**HDC-2022-00023****Address: 617 N. 6<sup>th</sup> Street****Applicant: Manuel Fernandez, Owner****HARB Meeting Date: June 6, 2022****Building Description:**

Provided by Applicant and Staff: Replace 2 vinyl windows in 3<sup>rd</sup> floor front façade with vinyl windows of the same size.

**Primary Façade (Google Street View)**

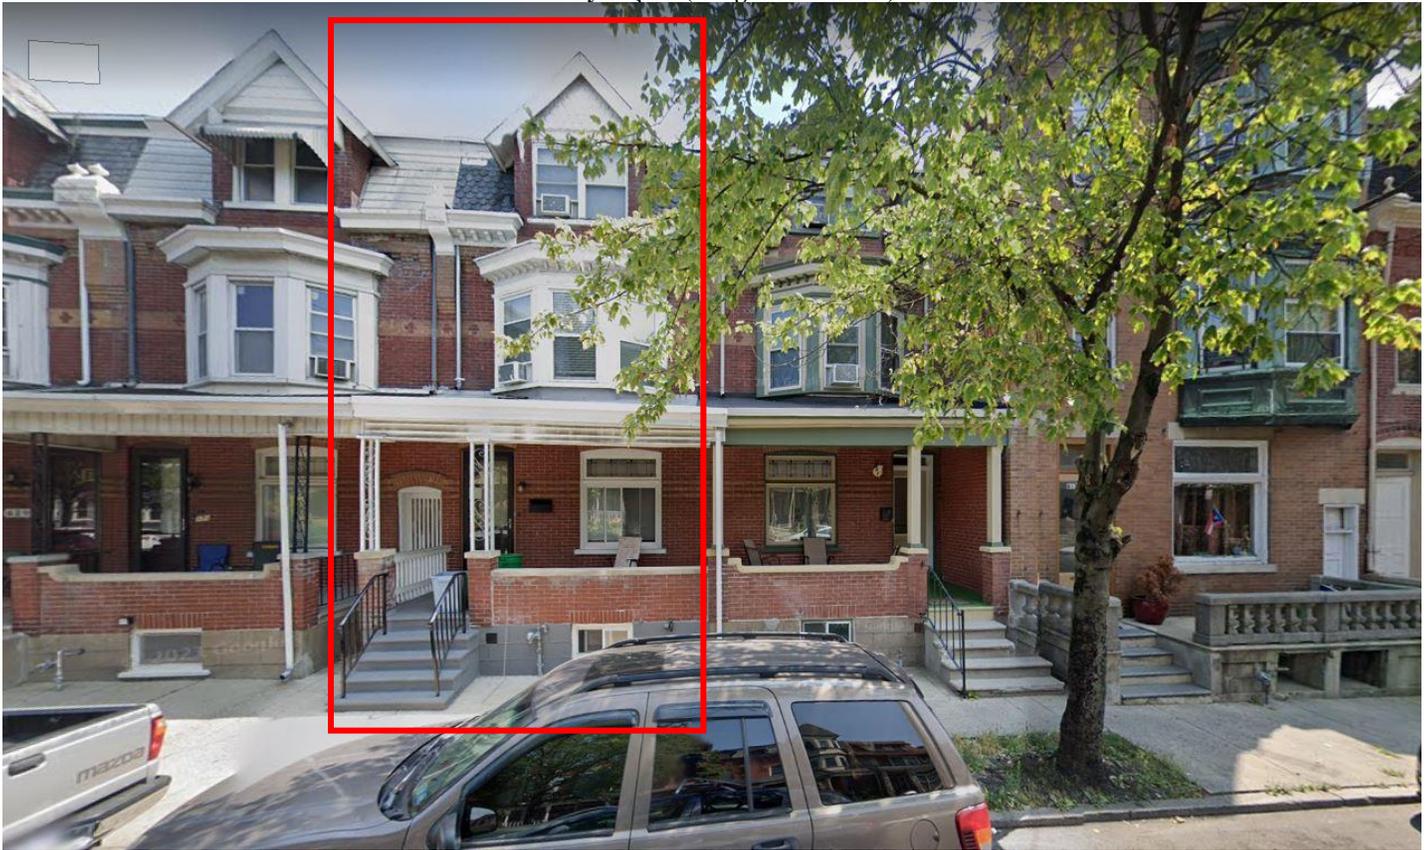
Installation of new vinyl windows is not consistent with the Guidelines, specifically Guideline 3.5.9. Replacement of existing vinyl windows is appropriate; however, an alternative replacement material—such as aluminum-clad wood windows—would be appropriate.

Discussion among HARB members on replacement of non-original windows, and the definition of in-kind replacement. It was determined that in-kind replacement refers to original and historic material and not what might be present currently. A range of appropriate replacement materials for non-original, previously-altered windows is allowed by the Guidelines.

GL stated vinyl is not an acceptable replacement material according to the Guidelines.

HARB member Glenn Lichtenwalner made a motion to deny the application presented *on 06/06/22* for replacement of 2 vinyl windows on the 3rd floor front façade at *617 N. 6th Street* as submitted and finds the application is not in compliance with Chapter 3, Section 3.5 Windows of the Historic District Design Guidelines. Recommendation is for applicant to comply with in-kind replacement materials and acceptable alternative materials as described in the Historic District Design Guidelines and there are no unique circumstances to this application.
